## MEMORANDUM

FOUNDATION INVESTIGATION REPORT

Eastbound Lane and Westbound Lane  
Structures at the Crossing of  
Anderson Rd. and Proposed Hwy. #417  
District No. 9 (Ottawa)

V.J. 67-P-112 -- W.P. 34-66-04

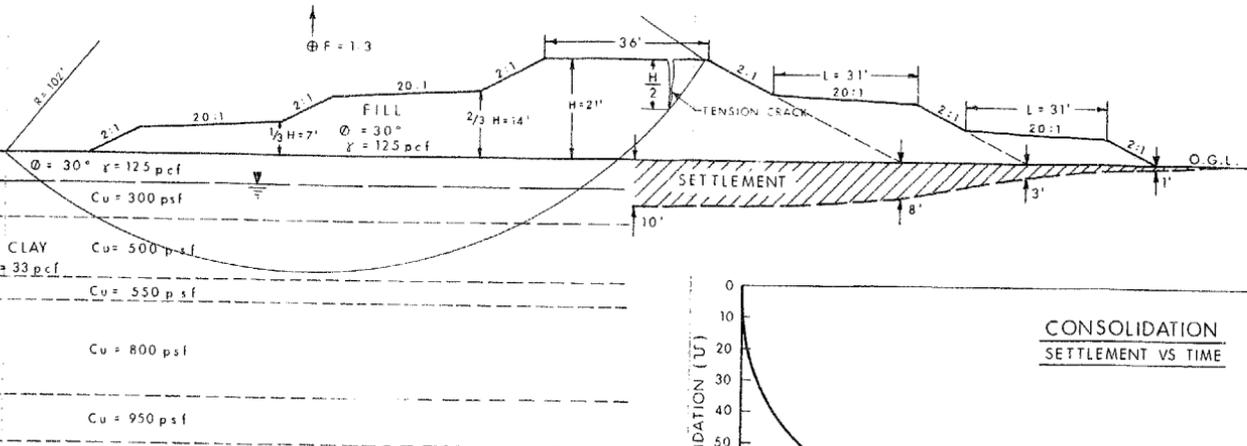
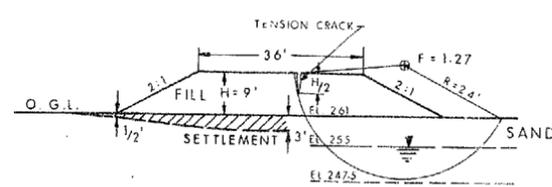
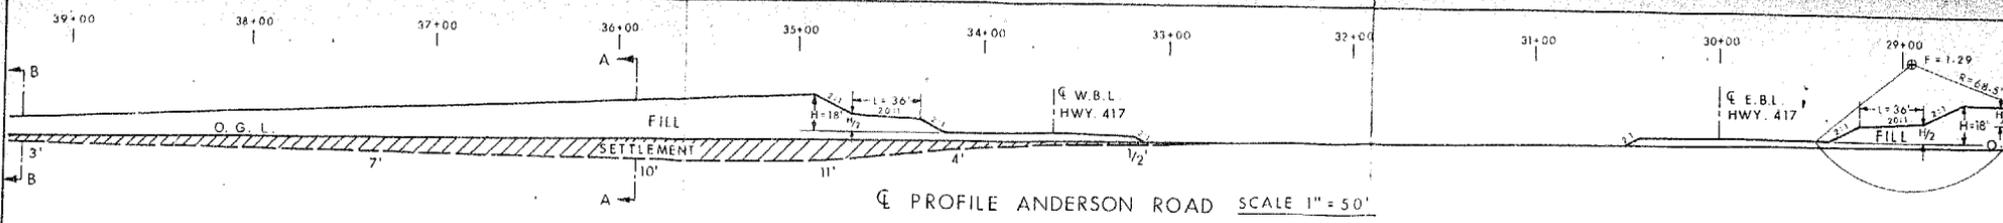
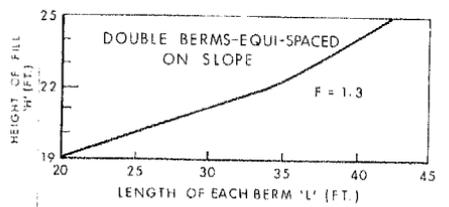
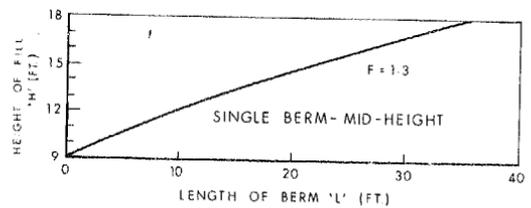
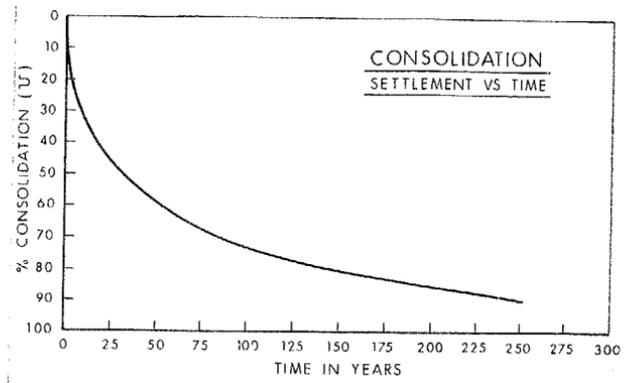
Figure No. 2, contained in the Appendix of the above mentioned report, has been revised.

Would you, therefore, please delete and destroy the existing Figure No. 2 and insert the revision attached hereto.
